IRIGARAY URANIUM SOLUTION MINING PROJECT

WYOMING MINERAL CORPORATION**SEPTEMBER 1978****Docket No. 40-8502****U. S. Nuclear Regulatory Commission****Office of Nuclear Material
Safety and Safeguards**

FINAL ENVIRONMENTAL STATEMENT
related to the
WYOMING MINERAL CORPORATION
IRIGARAY URANIUM SOLUTION MINING PROJECT

After comments on the Draft Environmental Statement had been received and considered, the staff prepared this Final Environmental Statement. It includes discussion of questions and comments submitted by reviewing agencies or individuals. Further environmental considerations are made on the basis of these comments and combined with the previous evaluation; the total environmental costs are then evaluated and weighed against the environmental, economic, technical, and other benefits to be derived from the proposed project. It is concluded (Sect. 13) that the overall benefit-cost balance for the limited Irigaray project is favorable and that the indicated action is that of granting a source material license for the Irigaray project.

Fig. 4.7. Locations of evaporation ponds for process plant liquid wastes at the proposed Irigaray site. Provided by the applicant. Note: The revised dimensions of the waste ponds are shown in Table 4.4.

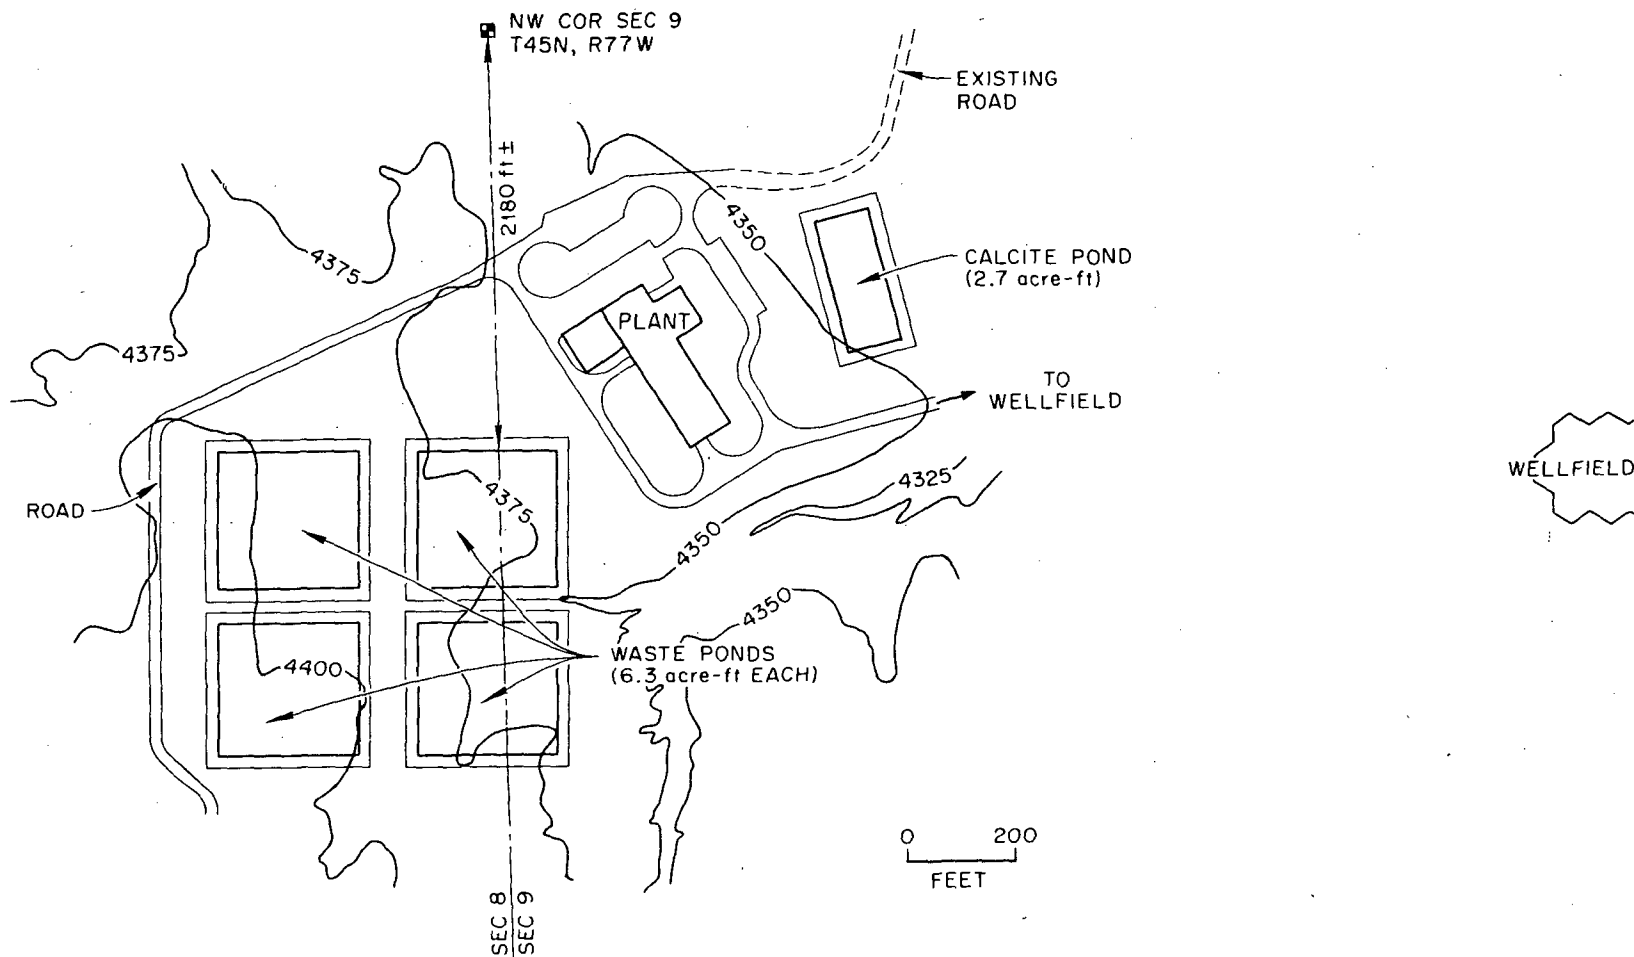
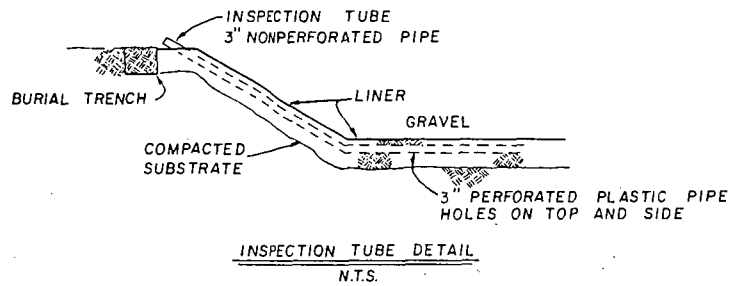
Figure 4.7 (page 4-13). (New information). Please note that the pond configurations given above and as shown on the enclosed drawing entitled "General Mine Plan" (see Comment 8) update the pond configurations shown in Figure 4.7.

Figure 4.7 has been annotated to indicate that pond dimensions have been changed.

Fig. 4.8: Pond construction detail.

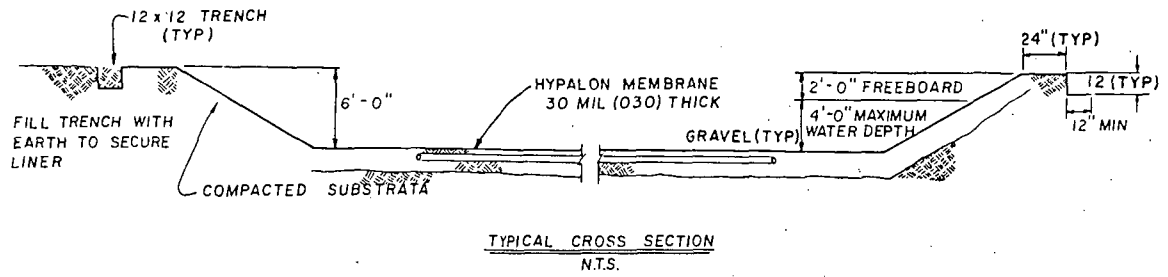
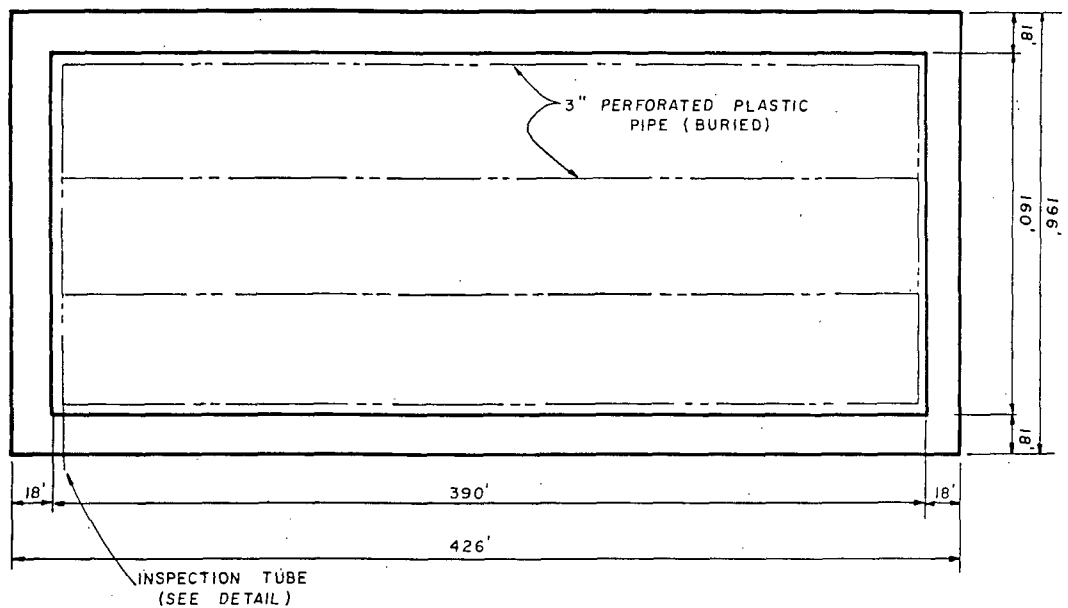
Figure 4.8 (page 4-14). (New information). The pond construction at Irigaray as currently planned is more appropriately described in the attached drawings designated "Dimensions of Rectangular Evaporation Ponds" and "Typical Cross Section and Inspection Tube Detail of Large Evaporation Ponds, etc."

Figure 4.8 has been changed to reflect this new information.

Fig. 5.2. Diagram of applicant's proposed restoration method for the Irigaray project.

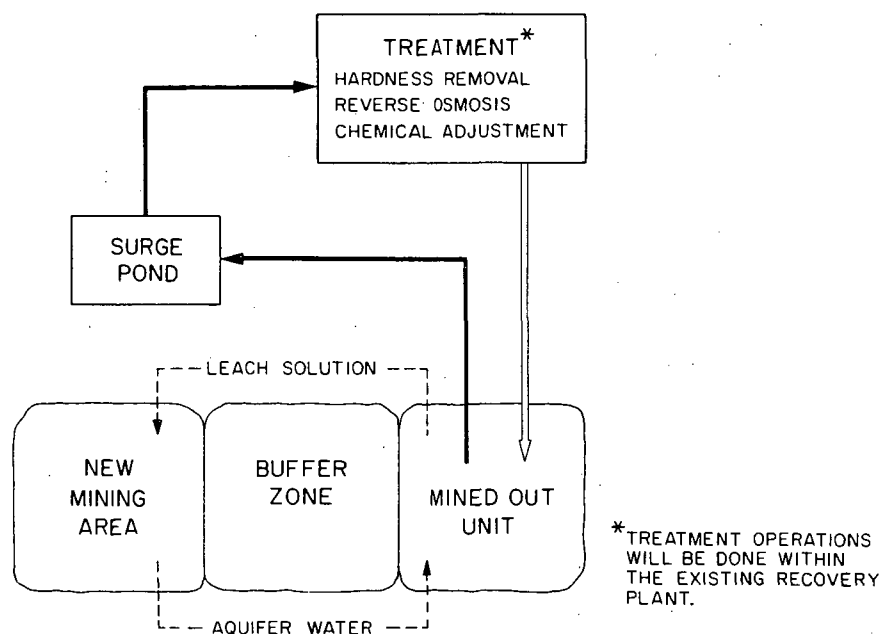
As one explicit clarification, WMC suggests that in Figure 5.2, the block labelled "Ponding" be changed to read "Surge Pond." The fifth and sixth sentences of the paragraph above the figure also should be edited to indicate clearly that restoration water will be extracted, treated and reinjected on a continuing basis.
